LAND USE BOARD APPLICATION

FOR OFFICIAL USE	ck xxx 9857	MP	
Date Rec'd: <u>8/21/2024</u>	Application #: <u>LB24-05</u>	Fee: <u>\$350</u>	Escrow: <u>\$750</u>

McGHEE RESIDENCE

43 Gravelly Point Road
Highlands, NJ

DRAWING NAME
PROPOSED EXTERIOR ELEVATIONS

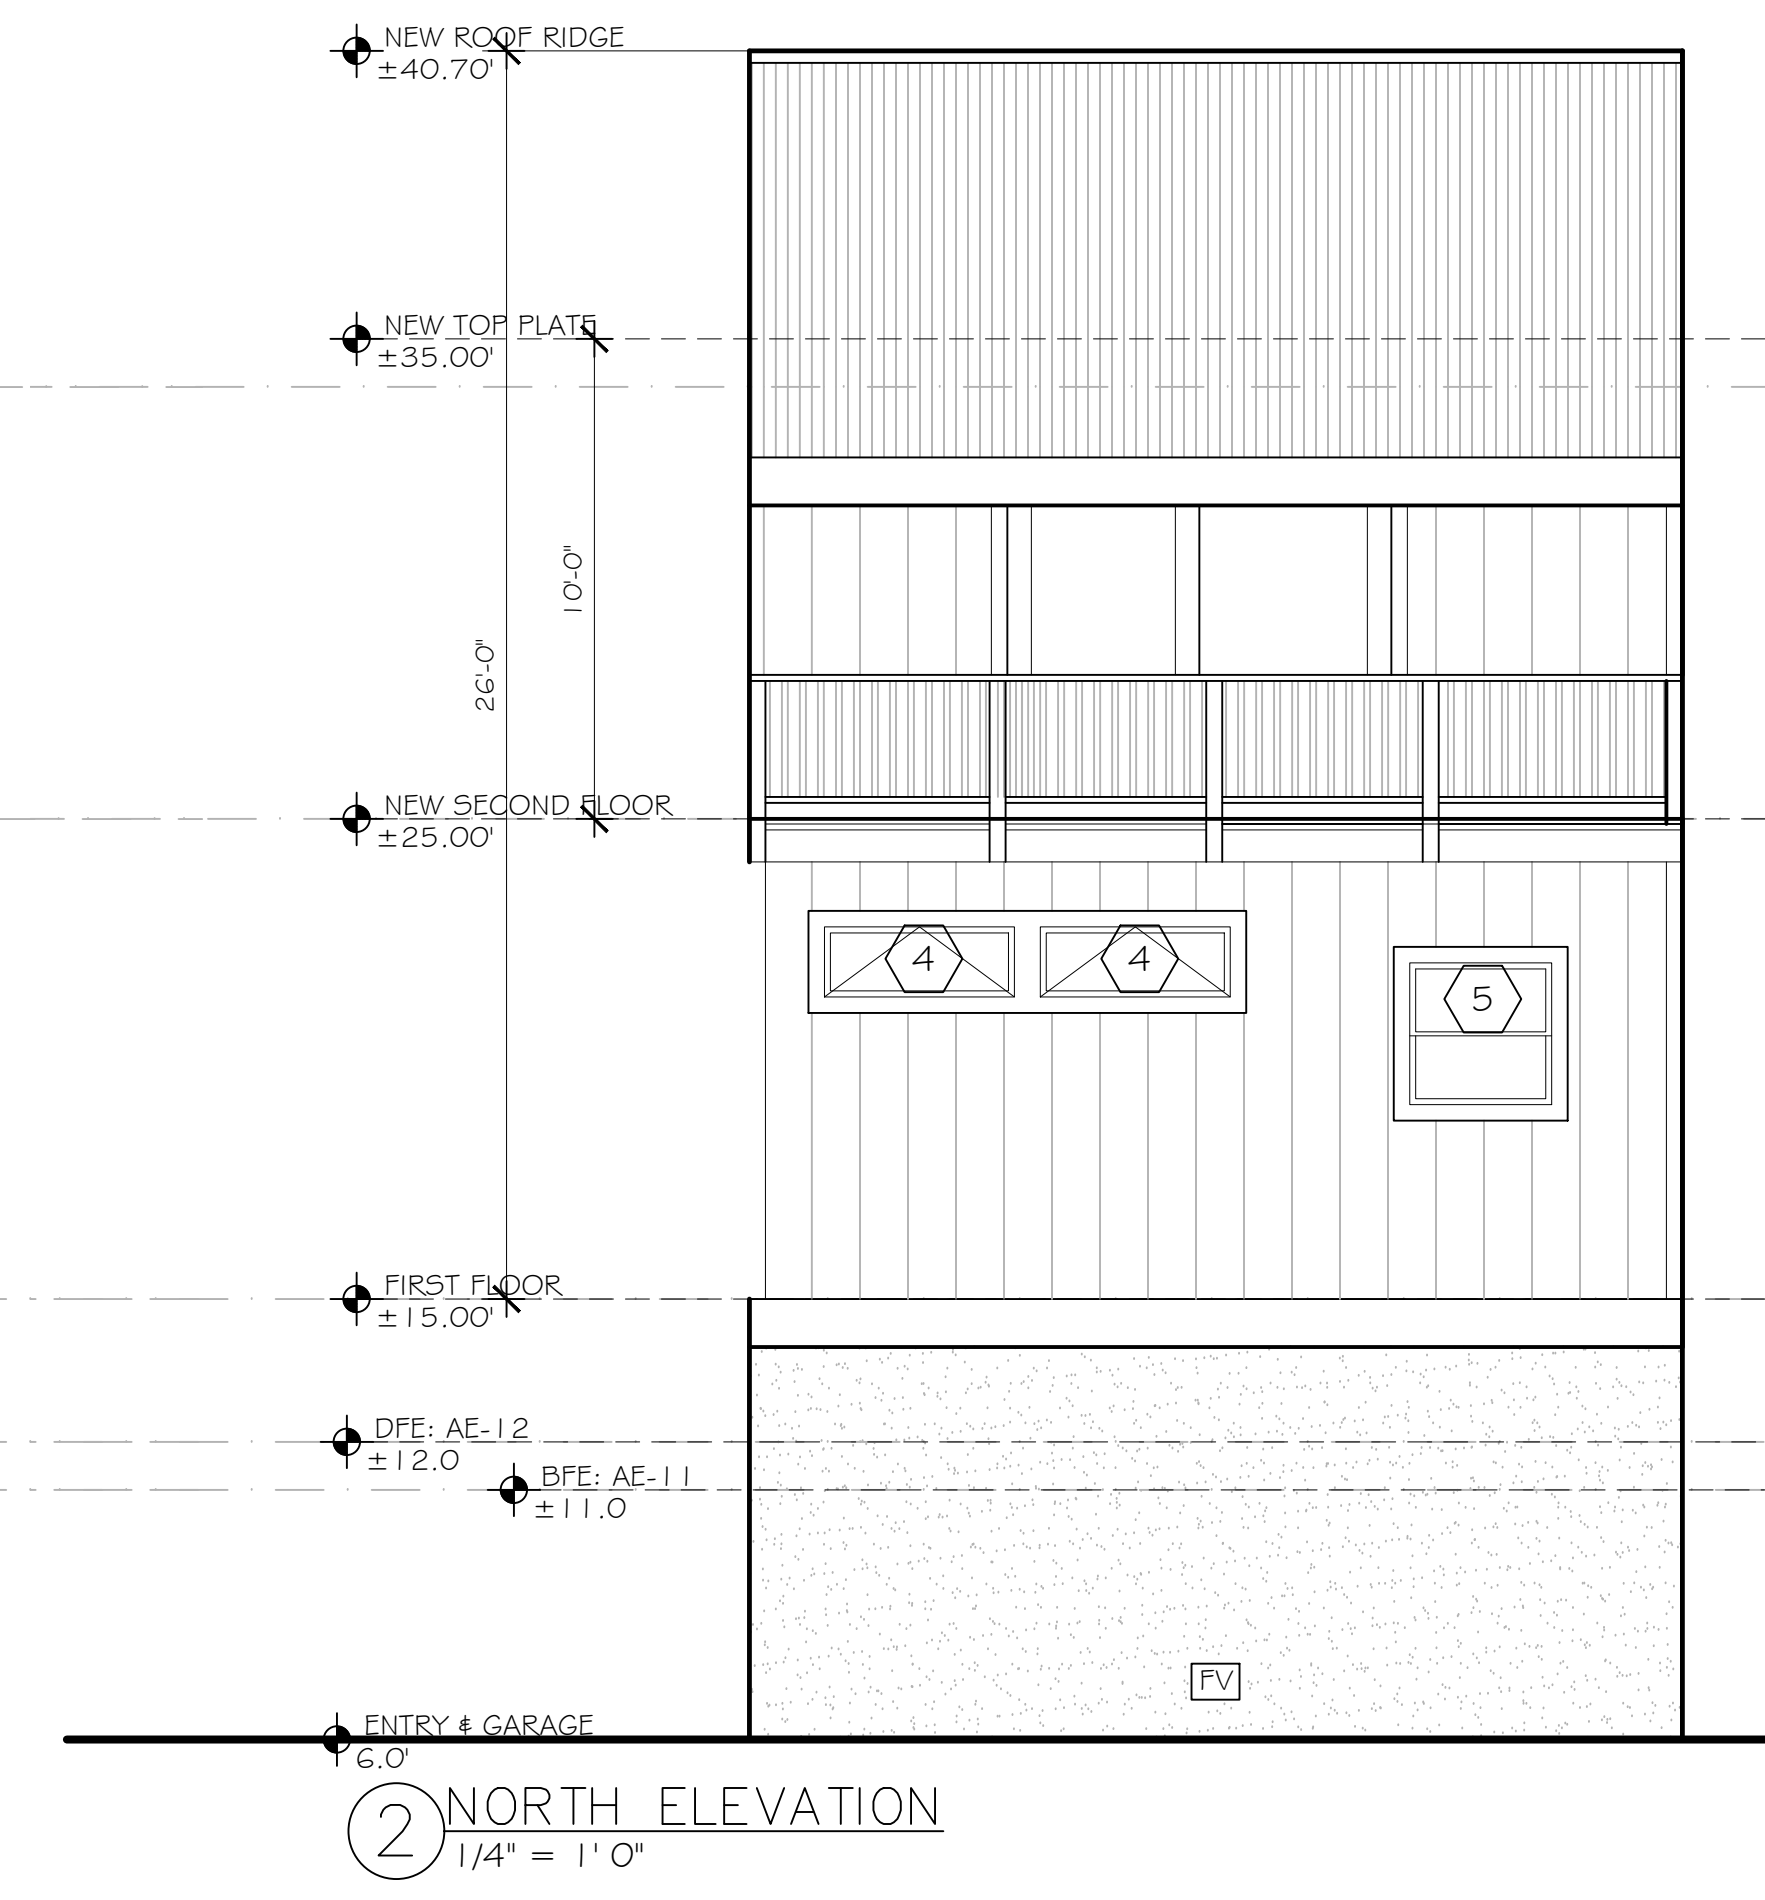
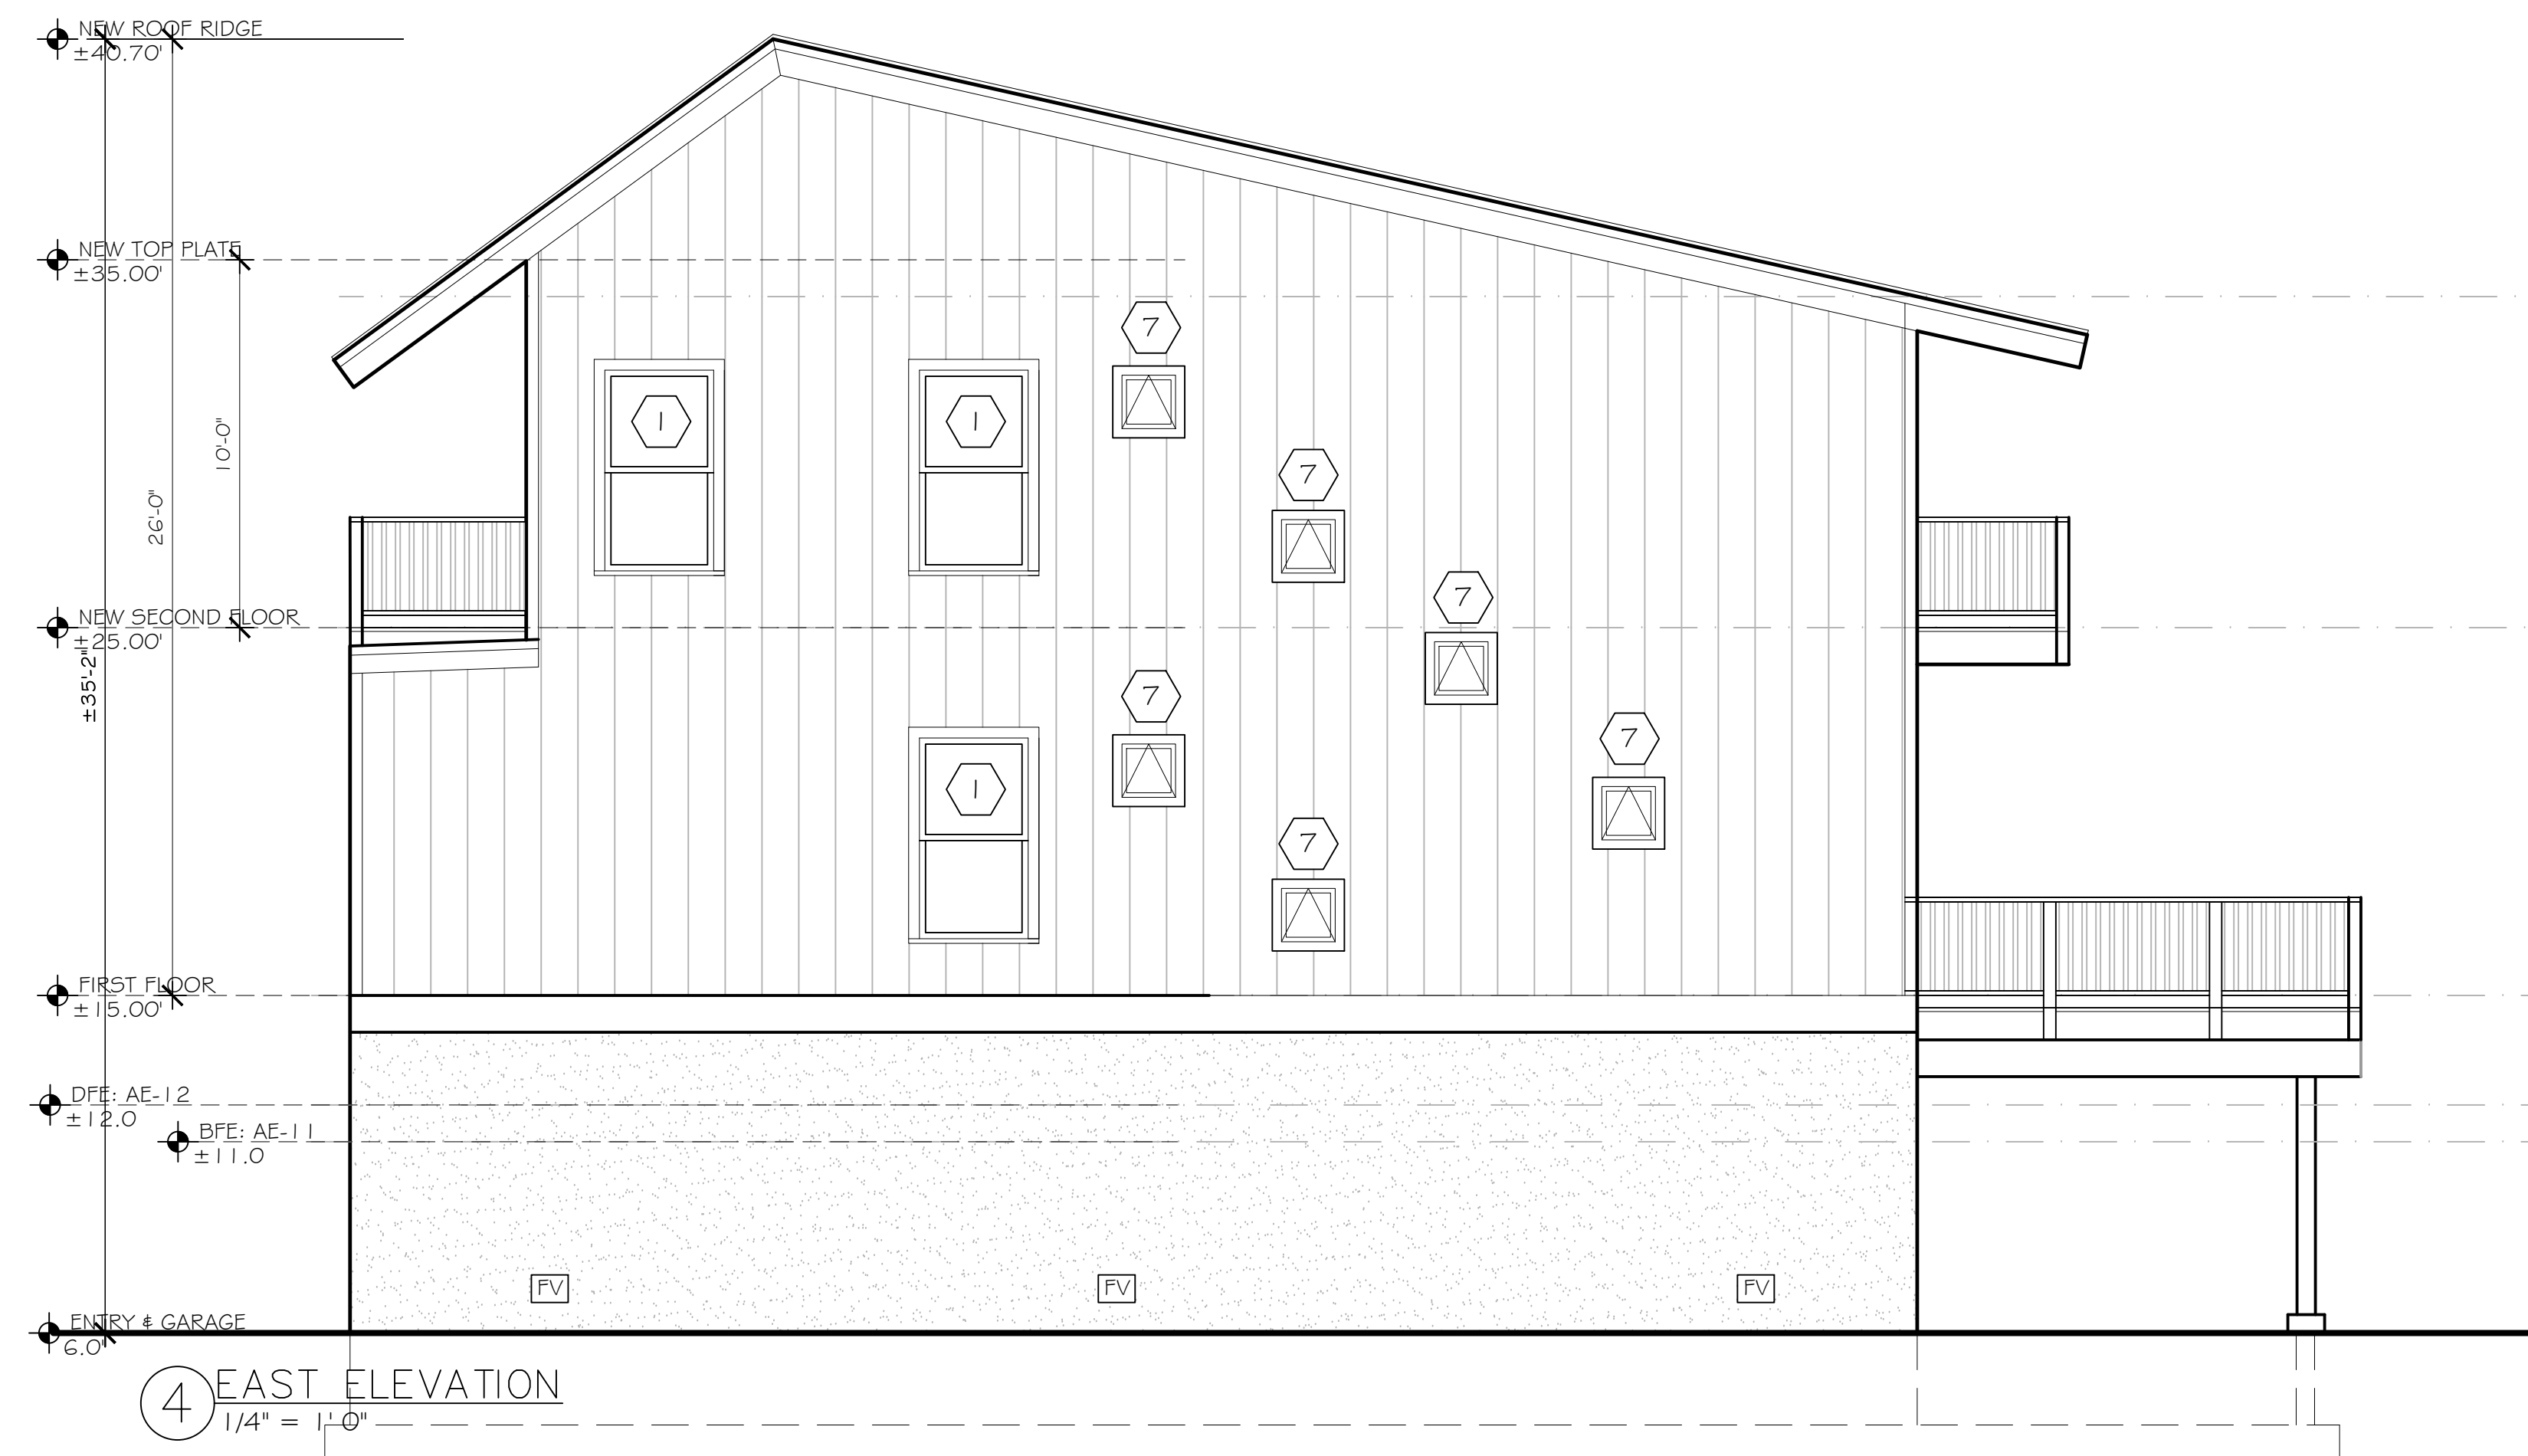
The building height is incorrectly shown on the architectural plans.

Please update the maximum building height based on §21-8 Definitions for Building Height and Grade Plane shown on the Exterior Elevations. One foot is to be added to the BFE within the Flood Hazard Area. In the case of sloped roofs, the average height is the mid-point between the lowest roof eave of the top floor and the roof ridge.
